## **Phase 2 – Catalyst, Bicester** **Technical Note – LLFA / CDC Drainage Response**

This technical note has been produced as an addendum to Application No: 22/03677/DISC relating to discharge of Condition 40 (SW Drainage). This condition has been partially discharged for Phase 1 which is now complete. Phase 2 (Units 5-9) is the next and final phase of development for this application. Please find below Bailey Johnson Hayes responses to consultee comments received to date.

DITCH 'A' CAPACITY CHECK

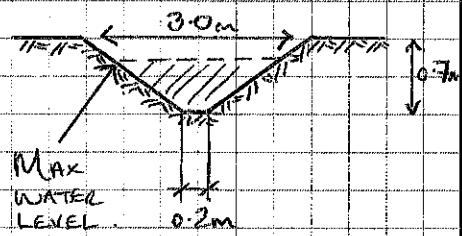
4. Confirm the capacity of the ditch to take the proposed loads without posing flood risk to the neighbouring sites.

Please find attached Ditch Capacity Calculations to confirm ditches are OK.

THE MAXIMUM VELOCITY AND MAXIMUM DISCHARGE ARE CALCULATED BELOW USING MANNING'S FORMULA ASSUMING THE CHANNEL IS 75% FULL.

$$V = \frac{R^{2/3} \times S^{1/2}}{n} = \frac{0.246^{2/3} \times 0.005^{1/2}}{0.05} = 0.555 \text{ m/s}$$

$$Q = A \times V = 0.6 \times 0.555 \times 0.75 = \underline{250 \text{ l/s}}$$

$$Q = CiA = \frac{0.5 \times 0.826 \times 20,000}{60 \times 60} = 0.23 \text{ m}^3/\text{s} \text{ OR } 230 \text{ l/s} < 250 \text{ l/s OK.}$$

∴ DITCH IS CURRENTLY OK
